Summary Document for Replication of USBR Rule of Thumb Curve for Shasta Storage and CCR Temperature
 Prepared by the Southwest Fisheries Science Center on December 7th, 2016

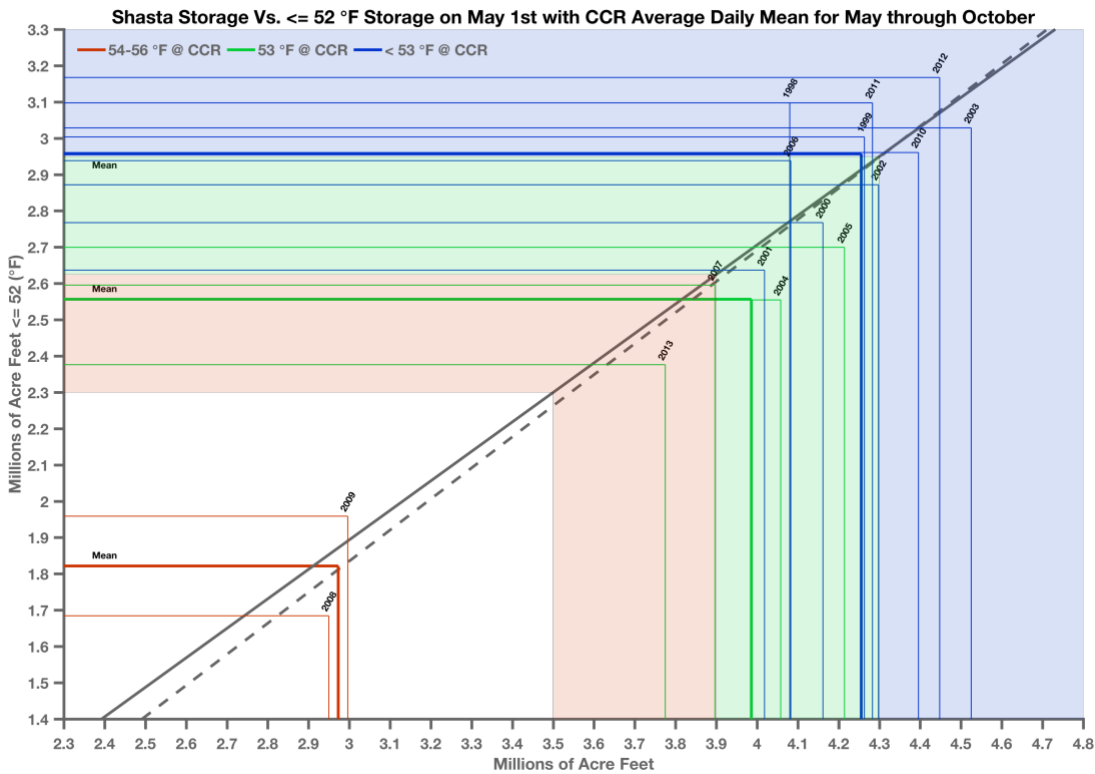
- USBR estimates do not align with NOAA estimates calculated from CDEC and USBR profile data under given assumptions. To resolve, some descriptions of the methods and data used to produce USBR estimate are needed.
- Trend between USBR and NOAA estimates are consistent that greater total/cold pool storage are associated with colder average temperatures at CCR (linear models between cold pool and storage relationship are also similar with USBR estimate slight biased upwards).
- USBR estimates indicates no overlap between CCR temperature criteria and total/cold pool storage while NOAA estimates indicates some overlap (especially under average daily maximum method), more clearly indicating other factors associated with CCR temperatures aside from May 1st total/cold pool storage.
